APPEAL SUMMARY

Appeal ID: 15961	Project Address: 2837 SE Colt Dr
Hearing Date: 10/11/17	Appellant Name: Thanh Huynh
Case No.: B-011	Appellant Phone: 5032921635
Appeal Type: Building	Plans Examiner/Inspector: Steven Mortensen
Project Type: commercial	Stories: 3 Occupancy: R-2 Construction Type: V-B
Building/Business Name: Wimbledon Square	Fire Sprinklers: No
Appeal Involves: Alteration of an existing structure	LUR or Permit Application No.: 17-245139-CO
Plan Submitted Option: pdf [File 1] [File 2] [File 3] Proposed use: Stairway

RE: Wimbledon Square Stair 3 Riser Height Appeal [PSE #17-322]

WIMBLEDON SQUARE STAIR REPLACEMENT

EXISTING STAIR 2 & 3 PLAN
1/4" = 1'-0" 3 S2

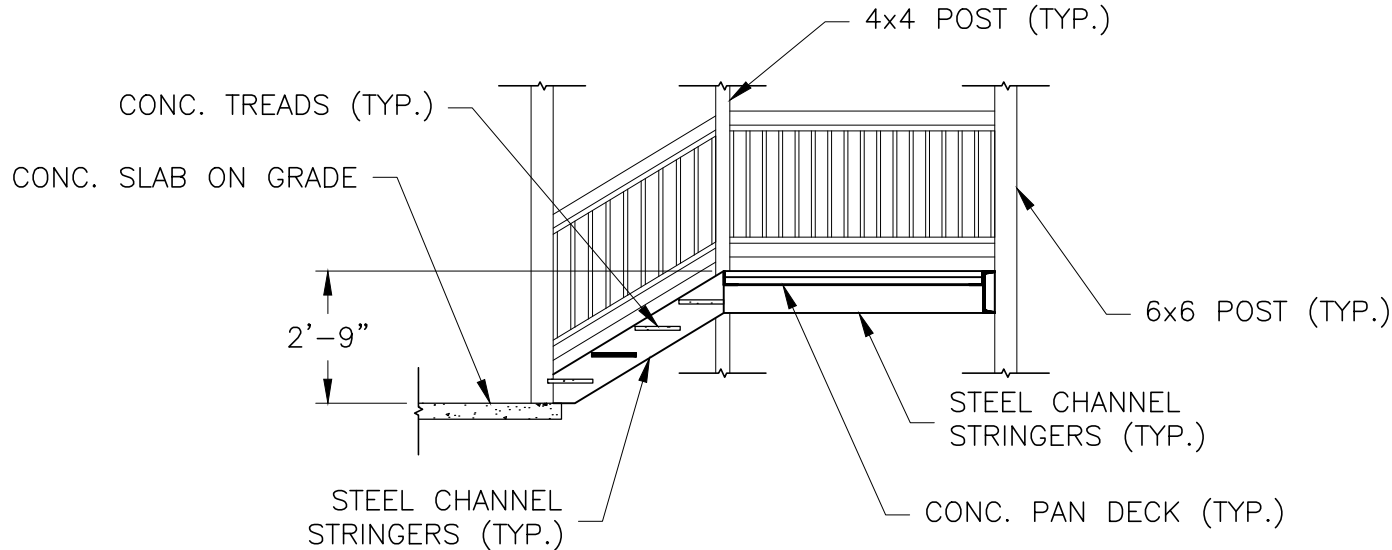
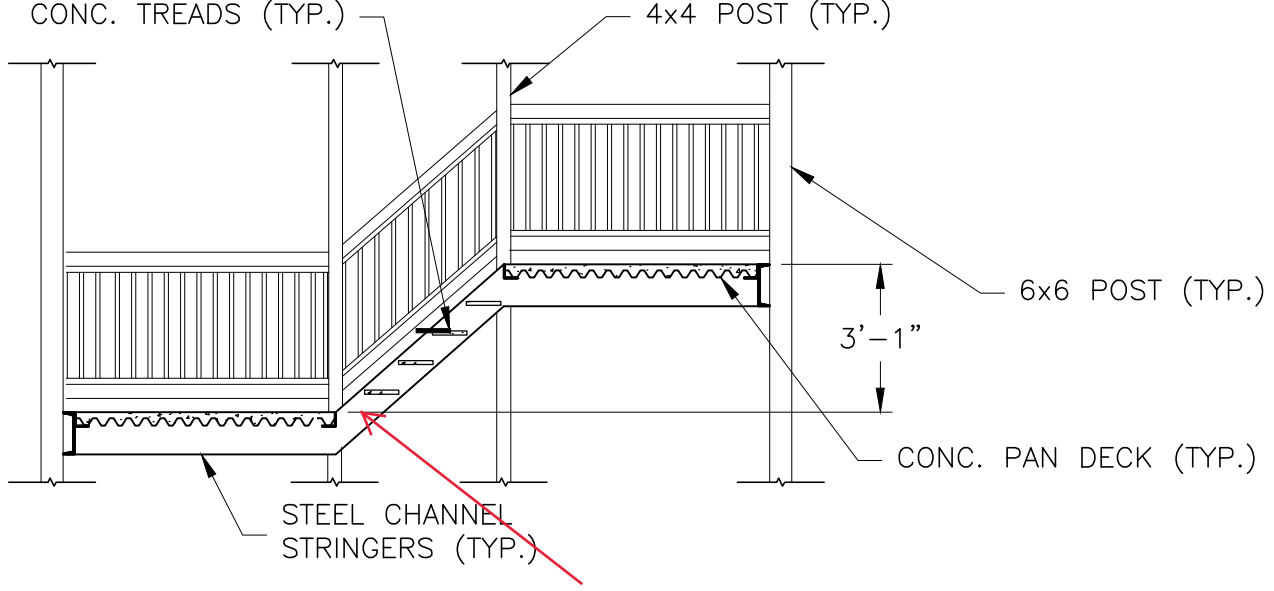
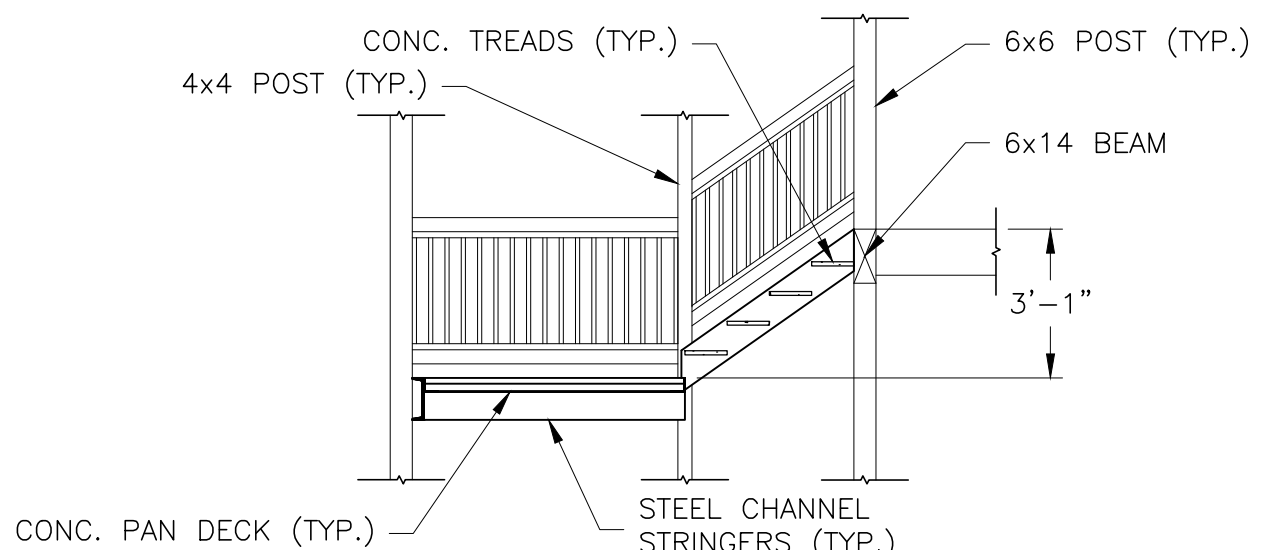
Requires The 2014 Oregon Structural Specialty Code section 1009.7.2 requires that stair riser heights shall be 7 inches (178 mm) maximum and 4 inches (102mm) minimum. This requirement is not met at stair 3 located at 2837 SE Colt Drive, Portland, OR 97202. This requirement is further detailed in the attached BDS Review Comments by the life safety plans reviewer.

The existing tread configuration at stair 3 currently exceeds the maximum riser height with a height of 7-7/16". We have proposed to adjust the heights of the stair landings to bring all of the stair treads at stair 3 to a consistent 7-1/8" by raising the lower landing 2-5/8" and the upper landing by 1-1/4" relative to their respective existing elevations. This preserves the existing egress walkways at the top and bottom of the stairs.

Reason for alternative The appeal request is strictly for stair 3 which cannot be brought up to code based upon the existing geometry of the existing stair tower. At the area in question only the stairs from the ground floor to the second level are being rebuilt. The stairs above are not being revised as part of the proposed work. It is not possible to reconfigure the existing stairs in question to meet the required tread height maximum of 7" without adding additional treads.

The existing stair tower prevents significant modification of the lower assembly without affecting head clearance requirements of the stairs directly above. While adjusting the landing heights would not bring all risers within code limitations, it would be an overall improvement to the existing stairway configuration by normalizing all riser heights.

Additionally, the proposed modifications to Stair 2 (which serves the same egress requirements as Stair 3) will meet the requirements for egress in the area served, thus making stair 3 both a non-primary and redundant means of egress. That is, if Stair 3 is removed from the existing system, the means of egress is still met by Stair 2 for the occupancy served.

Reconstruction of existing stairs to provide 7 1/8" risers: Granted provided other applicable provisions of OSSC Section 1009 are followed.
